STAFF REPORT: JULY 12, 2023 MEETING

APPLICATION NUMBER: 23-8397

ADDRESS: 14860 PIEDMONT

SCOPE: DEMOLISH GARAGE, REPLACE RAILING, REPLACE ORIGINAL WINDOWS WITH VINYL WINDOWS* (WORK DONE WITHOUT APPROVAL), REPLACE WOOD WINDOWS WITH VINYL WINDOWS

*Above: Google street view, 2022, unfinished wood railing is highly visible.
Left: Real estate listing photo, 2023.*

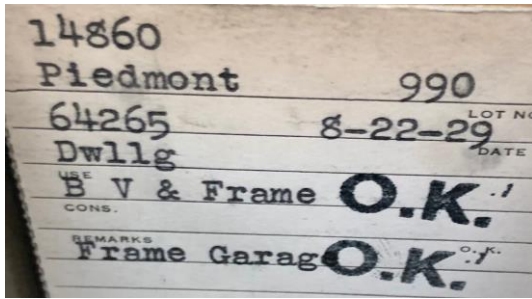
- The real estate listing image shows vinyl one-over-one windows in place at the front elevation.
- A tall, straight spindle/post metal railing replaced the non-approved wood railing.

- As noted earlier, the historic metal porch railing was removed between 2019 and 2022. The height of the low railing was below the windows and enclosed the raised porch without conflicting with the architectural detailing of the first floor window opening. The height of the current railing is out of scale with the historic structure. It is a bold, dominant form against the front elevation. The straight spindles are similar to the previous design; however, the lack of defined center and corner posts, and increased height, causes this component to appear less like a railing and more like a barrier against the front elevation.

Recommendation One – Denial – Replacement of wood windows, replacement of front porch railing

Sanborn Maps

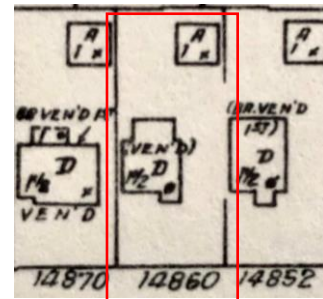
- The Sanborn maps and permit card show that the garage that was in place at time of designation was likely the original garage.

Staff finds that the proposal for the demolition of the garage will not alter the features and spaces that characterize the property and district and therefore recommends the Commission issue a Certificate of Appropriateness for the work as proposed as it meets the Secretary of the Interior’s Standards and the Elements of Design for the district.
